City of Sherwood  
PLANNING COMMISSION  
Sherwood City Hall & Public Library  
22560 SW Pine Street  
June 13, 2006  
Regular Meeting - 7:00 PM

6. **PUBLIC HEARING**  
**Woodhaven Crossing II -Site Plan Review (SP 06-02)**  
The Planning Commission will hold a Type 4 public hearing to review a site plan for 183 units of multi-family residential. The subject property is located at 21815 SW Pacific Highway and is identified as 2S130DB/Tax Lots 1000, 1001 and 1002 on the Washington County tax assessor map. The Commission will consider a staff report and recommendation based on the applicable portions of the Sherwood Zoning & Community Development Code (SZCDC - Part 3). (*Julia Hajduk, Senior Planner, Planning Department*)

PLANNING DEPARTMENT

The applicant has requested site plan approval for a 183 unit multi-family housing complex, which will be sold as condominiums. The proposal is to construct the units, parking, attached and detached garages, outdoor recreation areas, and construct road improvements to serve the site on tax lot 1000. The applicant has also requested a lot line adjustment to increase tax lot 1000 by .52 acres and decrease tax lot 1002 by .25 acres and tax lot 100

Figure 2-Clearance Area

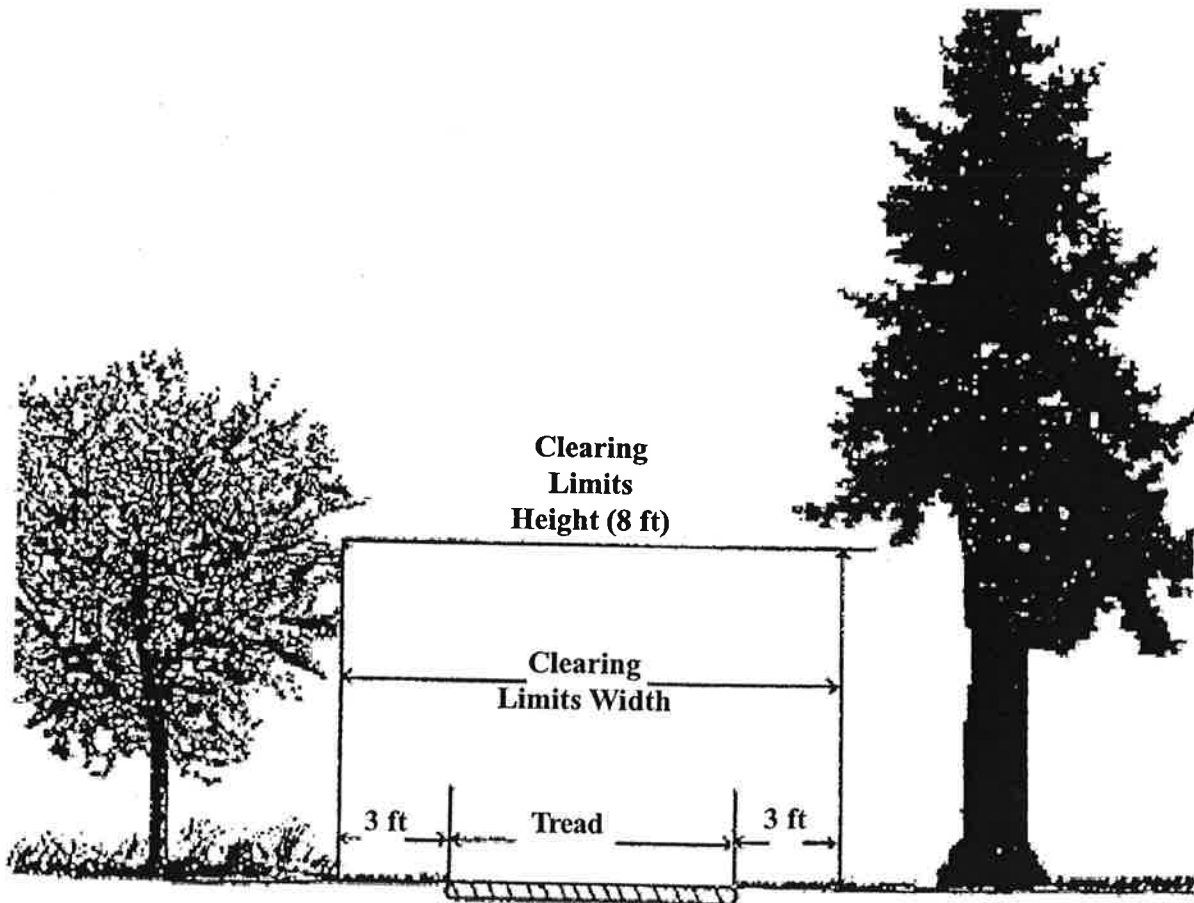
The proposal includes the intersection of SW Pacific Highway and SW Cedar Brook Way and three private driveway intersections with SW Cedar Brook Way. The site plan and landscape plans both show the 30 foot vision clearance triangle for SW Pacific Highway, SW Cedar Brook Way, and the private driveway intersections will be met. The landscaping within the vision clearance areas for the private driveways will be planted with lawn and Bearberry Cotoneaster. The landscaping at the intersection of Pacific Highway and Cedar Brook way is existing and is not proposed to be altered or planted further. No trees are shown to be planted within the vision clearance areas.
